# TOYOTA CUSTOMER SERVICES

Volume: XII  
Number: TC05-014  
Date: 06/27/2005  
 Action  
 Retain  
 Information

SUBJECT: SPECIAL SERVICE CAMPAIGN (SSC) – 50I  
2005 MY TACOMA REGULAR CAB BENCH SEAT WIRE HARNESS

**SPECIAL SERVICE CAMPAIGN 50I**

## **IV. BACKGROUND**

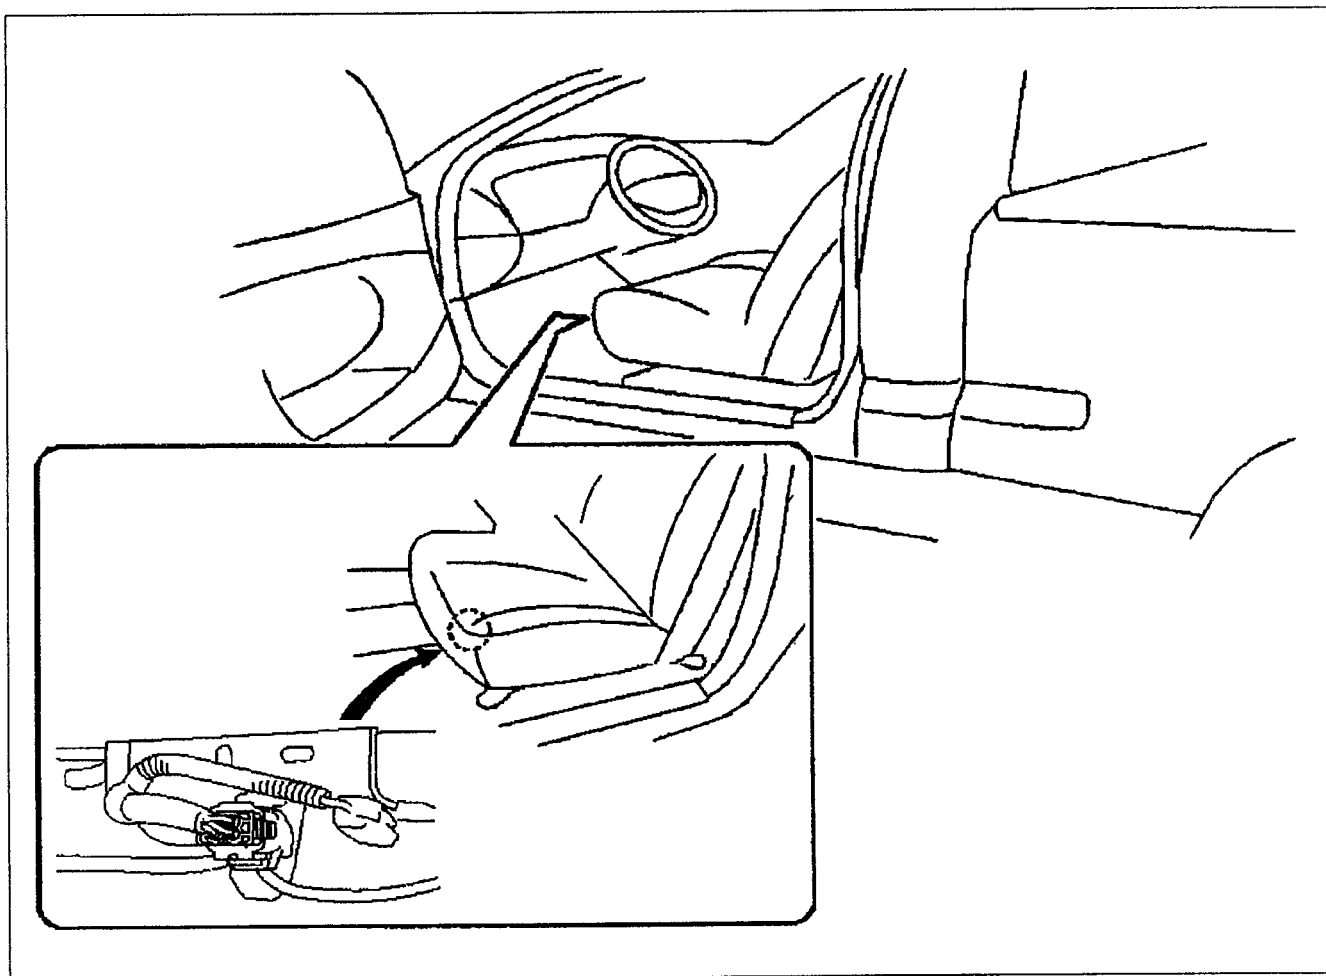
The Seat Position and Seat Belt Fastening Sensor Wire Harness Connector Pins were mispositioned due to an error during the manufacturing process. In the worst case, if the vehicle is involved in a crash with sufficient force to deploy the driver's-side airbag, the restraint performance of the driver's-side airbag will be reduced for certain seating positions and seat belt fastening conditions. Please note that even in this reduced restraint performance condition, the airbag performance meets the requirements of Federal Motor Vehicle Safety Standard ("FMVSS") 208.

## 2. INSPECT THE CONNECTOR WIRES

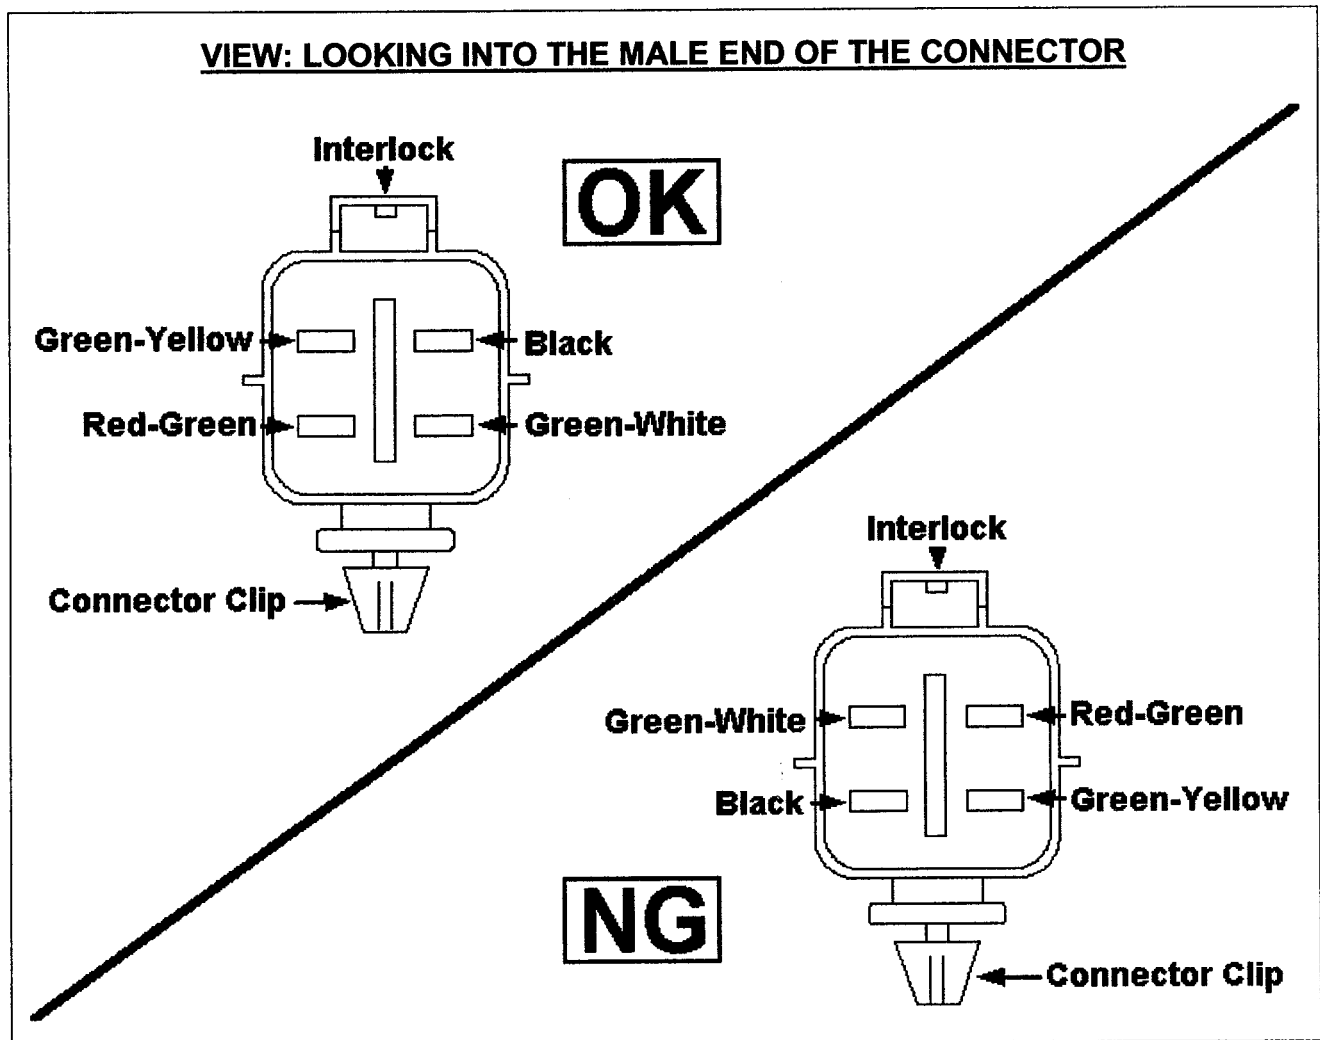
- (a) Check the wires of the floor wire harness connector (male end) to see if they are in the correct position.

**Make sure to view the male end of the connector in the proper orientation as shown in the illustration.**

- (b) If the connector wires are correctly installed, installation of the wire seat jumper is NOT REQUIRED, proceed to section "VI. SSC COMPLETION LABEL INSTALLATION".
- (c) If the connector wires were NOT correctly installed, proceed to step "B. INSTALL THE WIRE SEAT JUMPER".
